Change Order #3 Las Milpas Road

Project: Las Milpas Road

Change Order #3 has been approved to make the following changes.

Added Sheets: Sht. 133c, 133d.

STA: 133+00

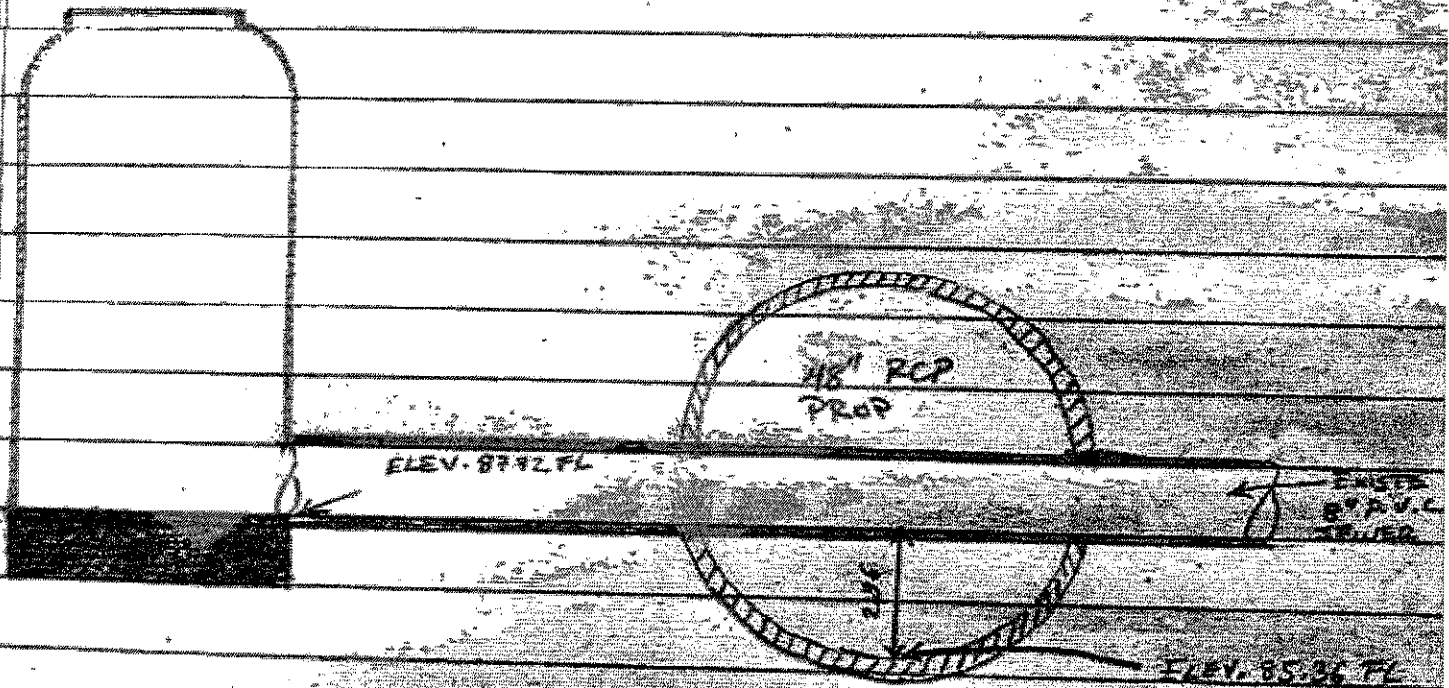
1. **At STA: 133+00 (+/-), Proposed 48" RCP (elevation 85.36 FL) will be in conflict with an existing Sewer Line that runs North and South (elevation 87.72 FL). The existing 48" Pipe has a Junction Box at this location. We Propose a CIP Junction Box at this location to avoid any delays.**

Information Requested: Please advise on how to proceed with this issues.

The request is approved. The sanitary sewer line intersects the 48" RCP right in the middle without room for adjustment.

Provide a quote for a 6'x4' Cast In Place(CIP) junction box with a steel casing for a City of Hidalgo 8" sanitary sewer line to pass through it.
